Service Bulletin

HTXG6DF, HTXD6i And STXD6i Hydrostatic Ride-On Trowels Spider Retaining Bolt Replacement And Spider Hub Cleaning

Product Group: Ride-On Trowels	Date Issued: 06/02/16	Service Bulletin No. TR20160601
Bulletin Type		Models/Series Affected:
<input checked="" type="checkbox"/> Mandatory <input type="checkbox"/> Information Only <input type="checkbox"/> Recommended Change		HTXG6DF S/N PA2003116 — PB2003172 HTXD6i S/N PA2003106 — PC2003212 STXD6i S/N PA2003099 — PC2003207

Figure 4. Removal Tool

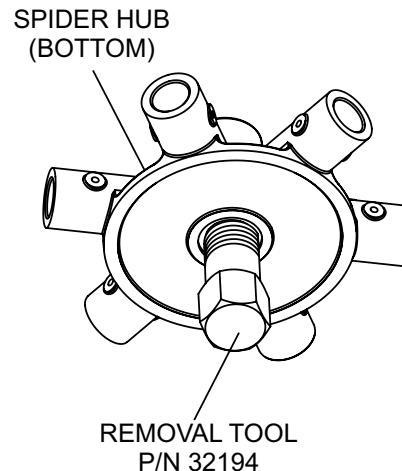
6. Insert spider removal tool (P/N 32194) or equivalent tool into the machined threads on spider hub (Figure 4) and torque to 300 ft-lb (407 N·m).

Figure 5. Cleaning Spider Hub Tapered Orifice

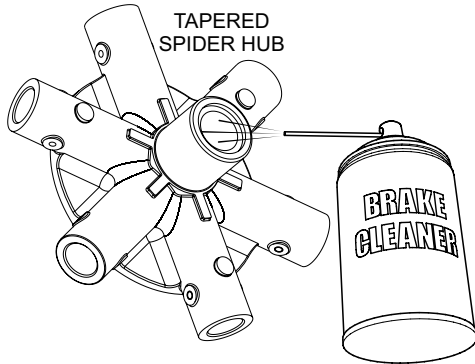
1. Before re-assembling, ensure that the tapered orifice (Figure 5) in the spider is clean. Spray with brake cleaner to remove any contaminants that may have accumulated on the tapered surface of the spider.

Figure 6. Residue Removal

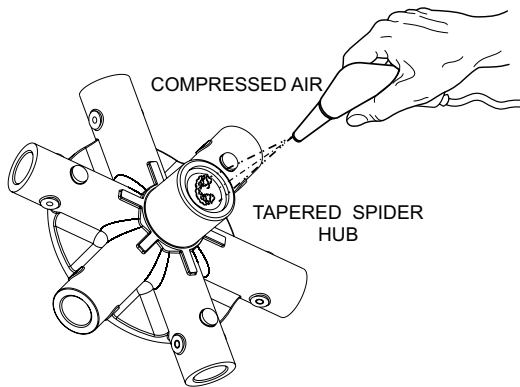
2. Use compressed air (Figure 6) to blow away any remaining residue that may have accumulated inside the spider hub orifice.

Figure 7. Applying Loctite™ (Hyd. Motor Shaft)

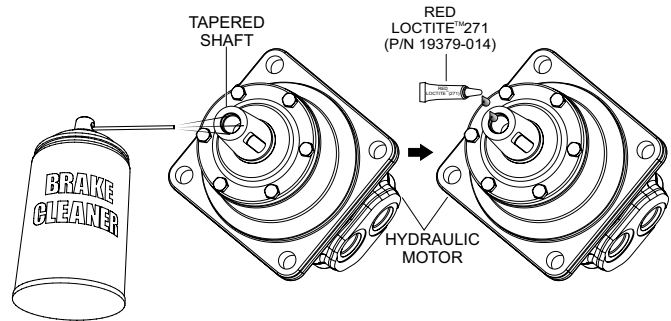
3. Make sure the threads inside the hydraulic drive motor shaft are clean and free of debris.
4. Spray with brake cleaner to remove any contaminants that may have accumulated on the hydraulic drive motor threads (Figure 7) or output shaft. Use compressed air to blow away any remaining residue.

5. Apply Red Loctite™ 271 (19379-014) to the female threads (Figure 7) on the hydraulic motor shaft.

Figure 8. Spider Retaining Screw

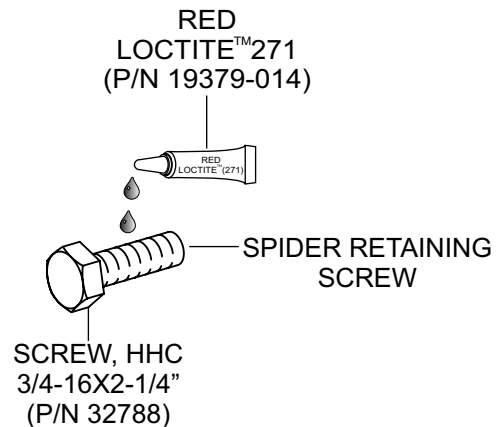
1. Place the washer that was removed earlier onto the **new** spider retaining screw (P/N 32788) and insert both items into the hydraulic motor shaft.
2. Using a torque wrench, torque spider retaining bolt to 350 ft-lb (475 N·m).
3. Remove the trowel from the jack-stands and place on a flat surface.
4. Start trowel as referenced in operator's manual. Run trowel for 15 minutes.
5. Lift and place trowel back onto jack-stands.
6. Remove spider retaining screw and apply Red Loctite™ 271 (19379-014) to the screw threads (Figure 8).

7. Insert washer and spider retaining screw into hydraulic motor shaft. Re-torque spider retaining screw to 350 ft-lb (475 N·m).
8. Insert snap-in spider dust cover plug.
